ROGERS CENTRAL KITCHEN HVAC PROJECT

ADDENDUM #1

Date Issued: April 4th, 2025

ROGERS MS CENTRAL KITCHEN (B#24-025) ADDENDUM 1 SPECIFICATION NARRATIVE

M-402

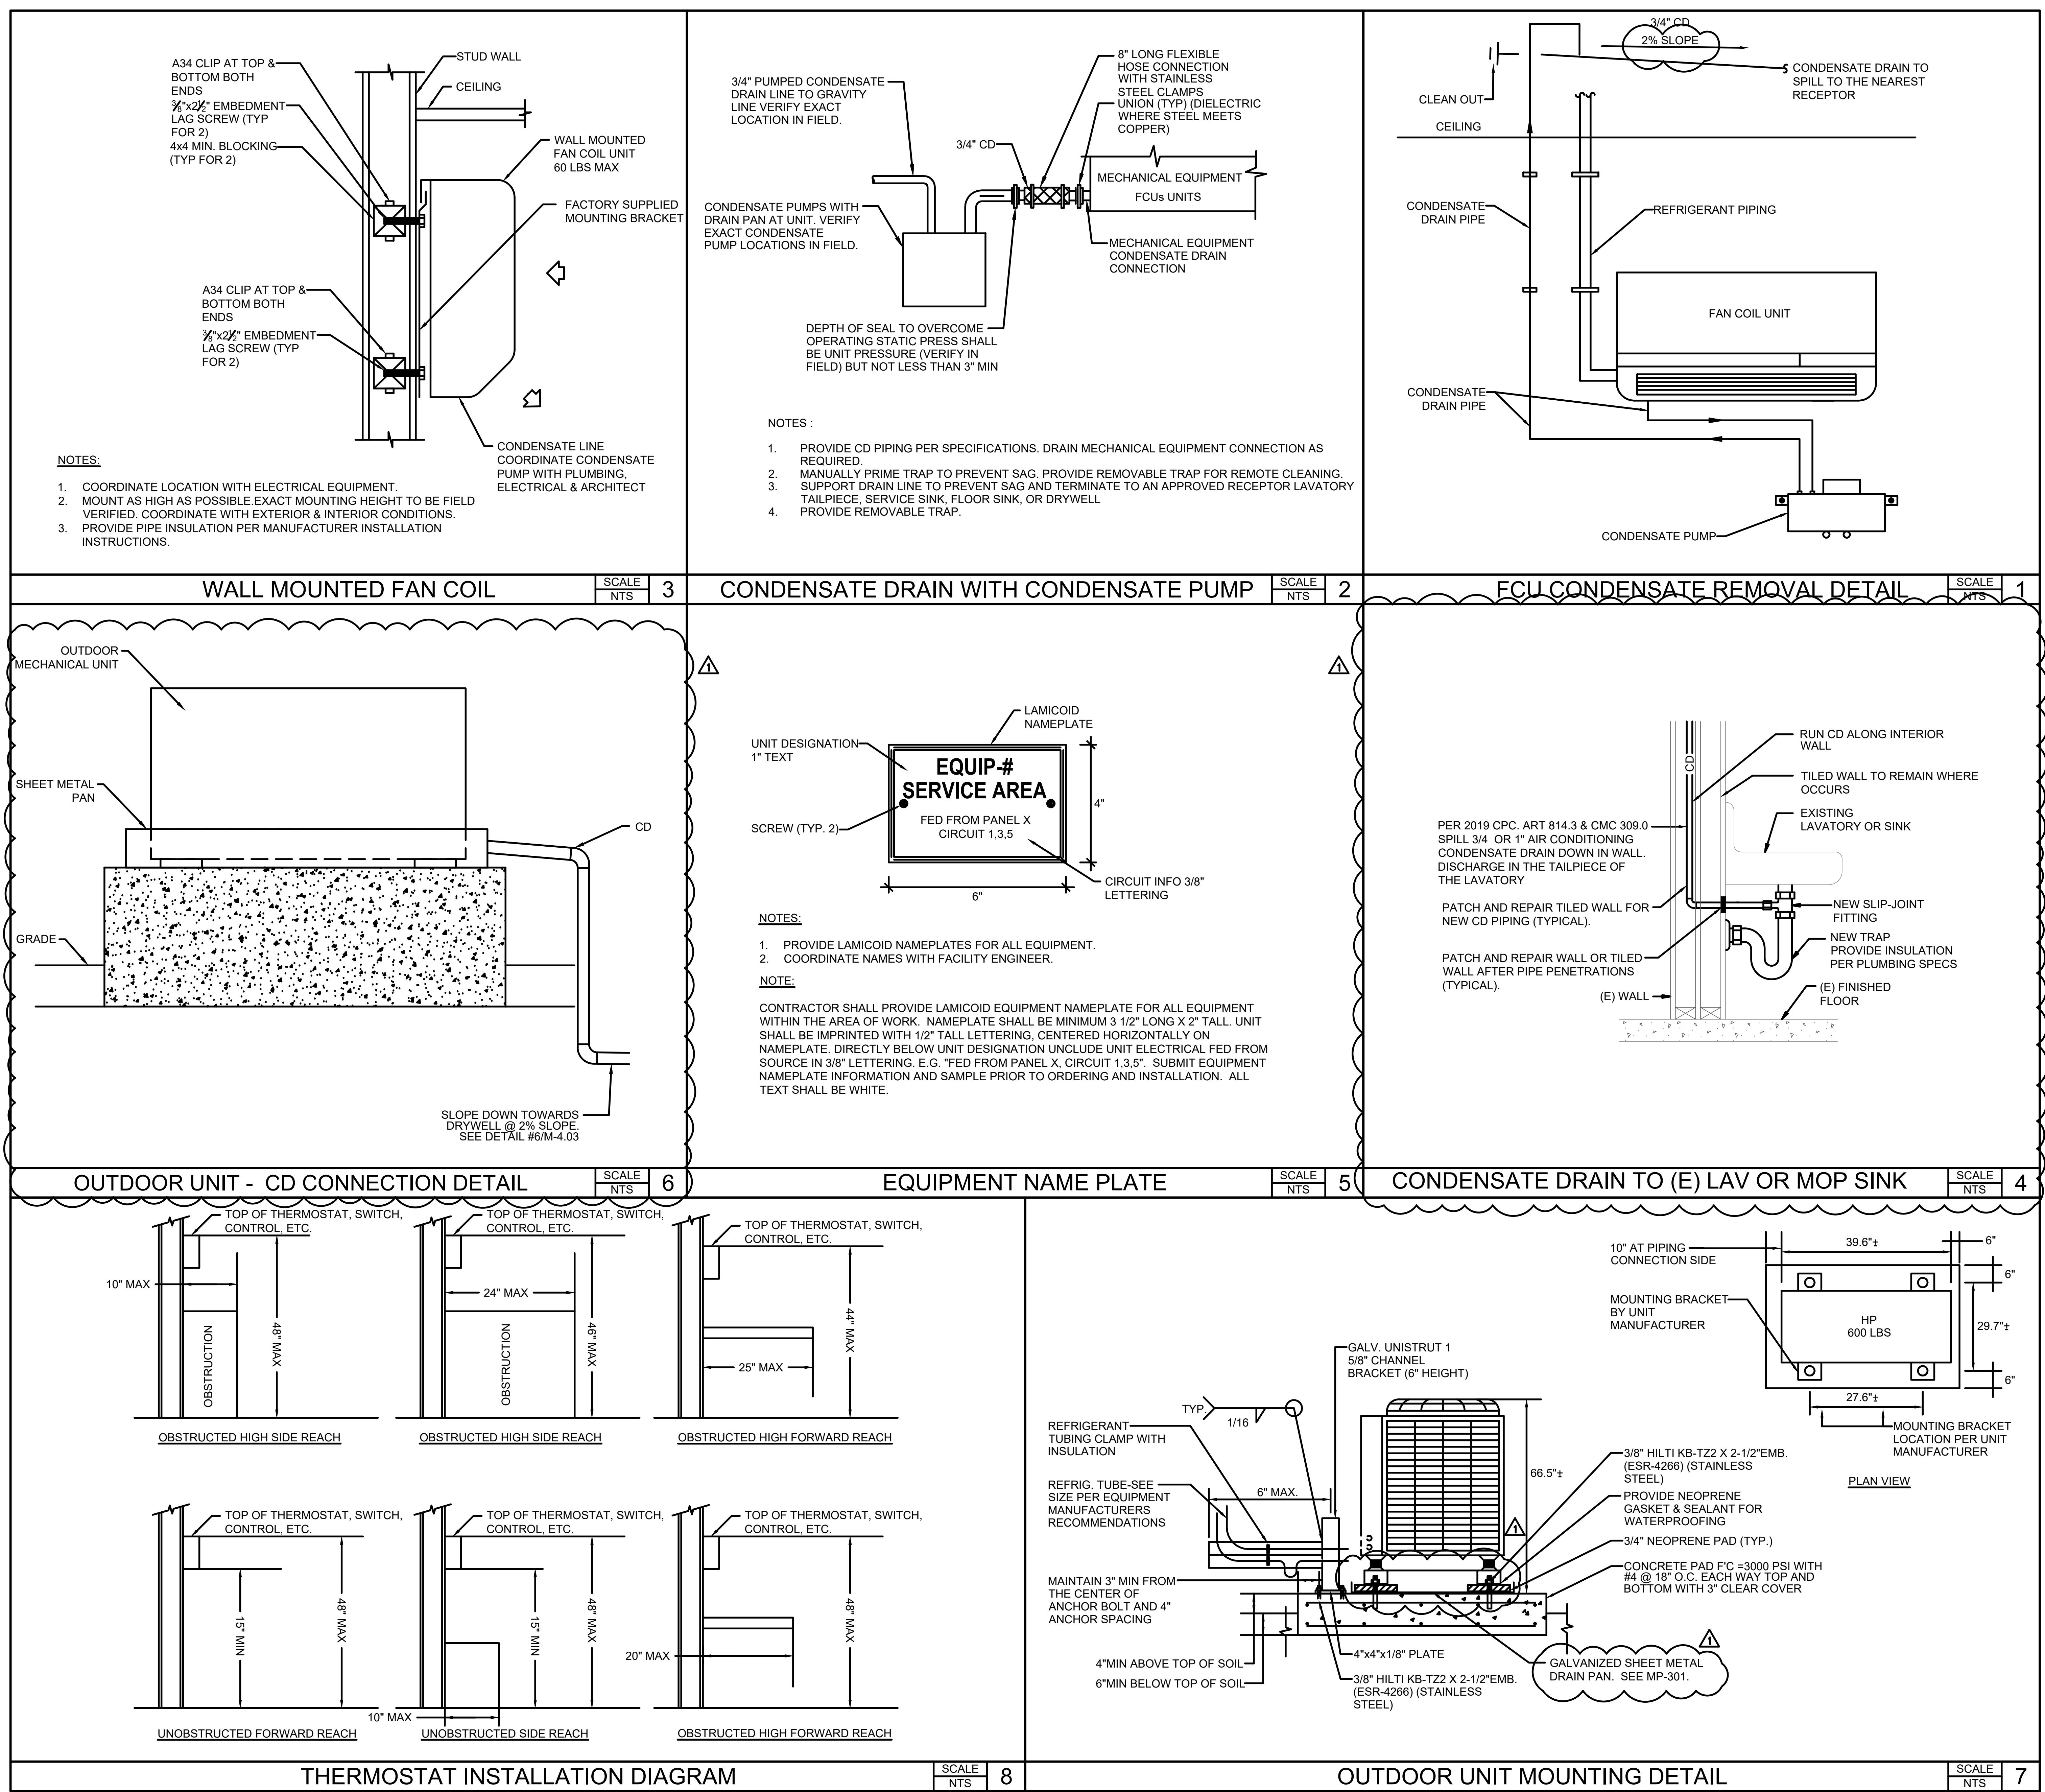
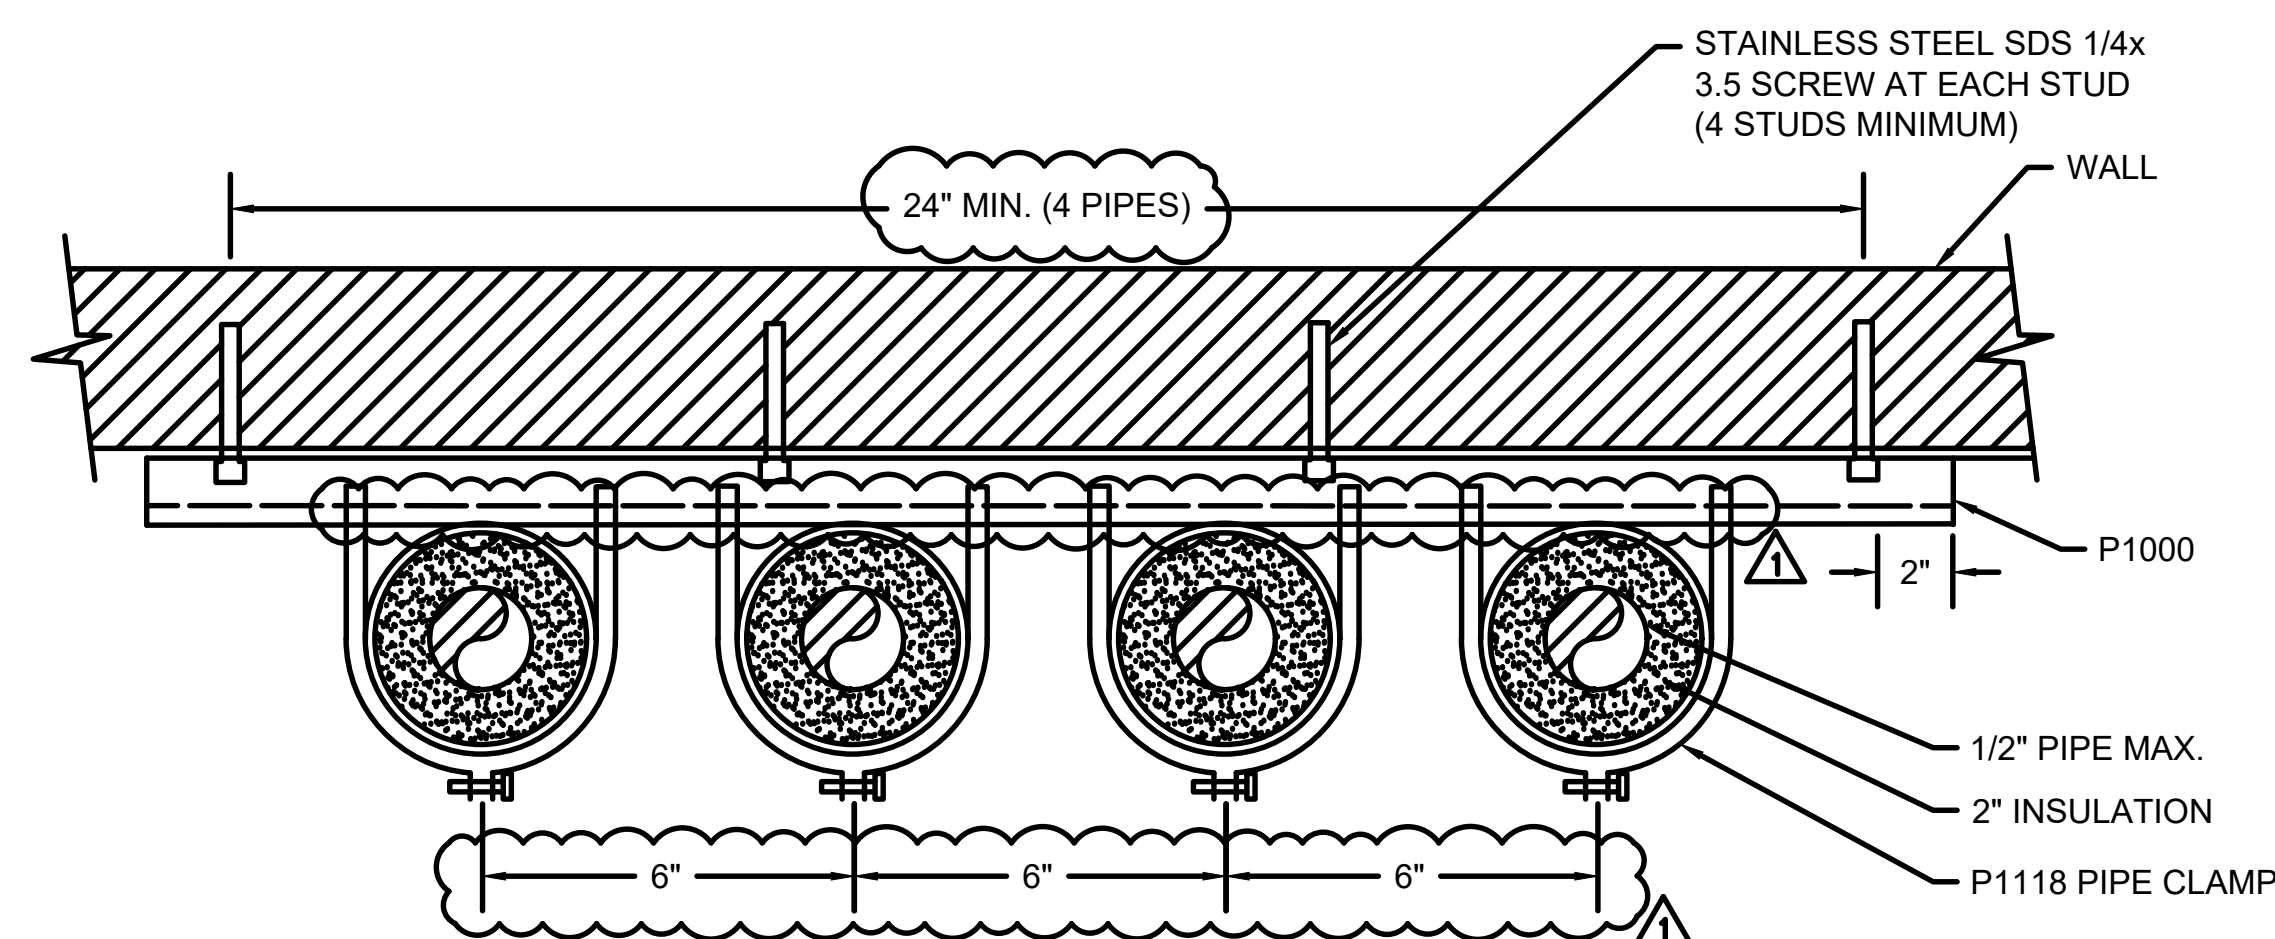
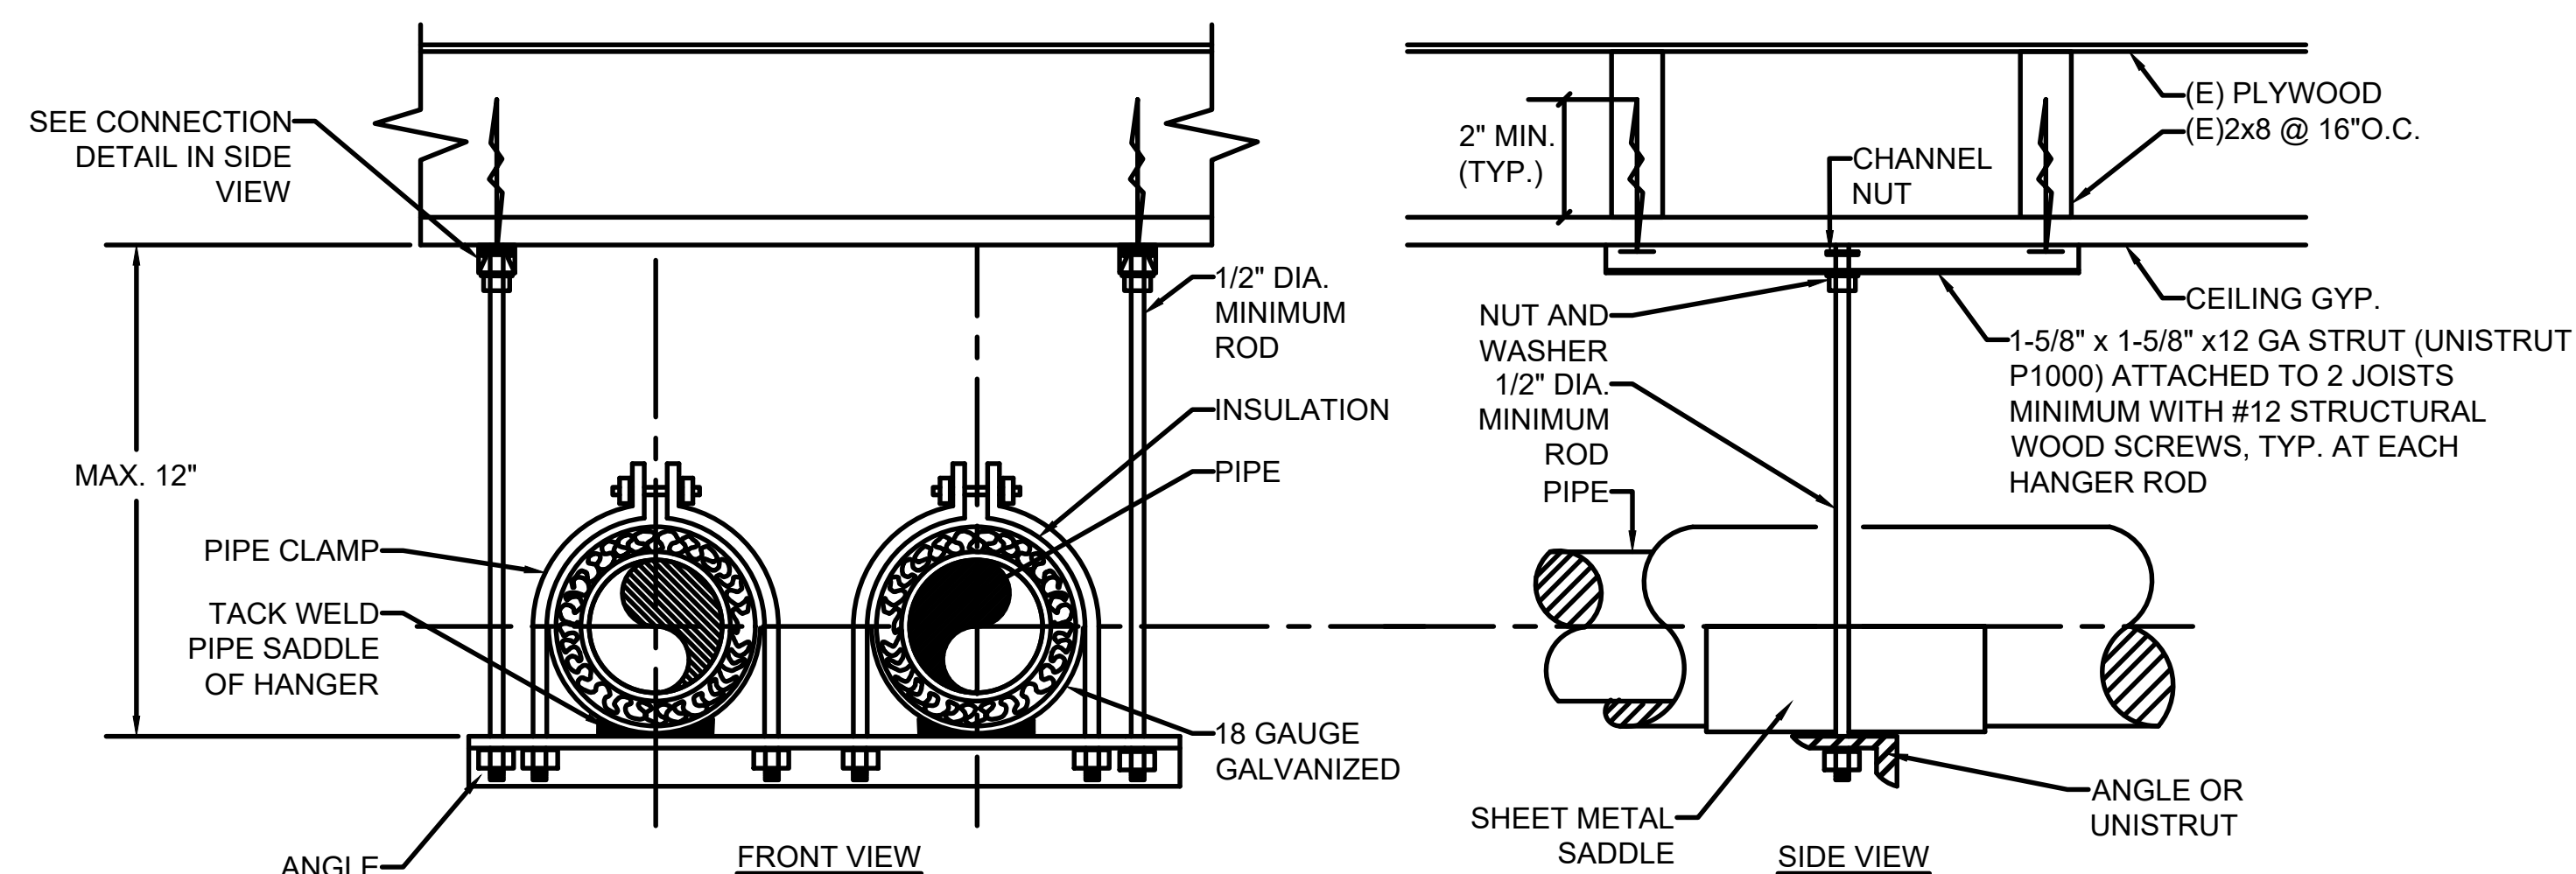
6. M-402 MECHANICAL DETAILS SHEET

- a) Revised Detail 1 – FCU Condensate Removal Detail so the CD slope is revised.
- b) Added Detail 4 - Condensate Drain to (E) Lav or Mop Sink.
- c) Revised Detail 6 - Outdoor Unit – CD Connection Detail so the draining method is simplified.
- d) Revised Detail 7 – Outdoor Unit Mounting Detail so the galvanized sheet metal pan is mounted directly to the concrete pad.
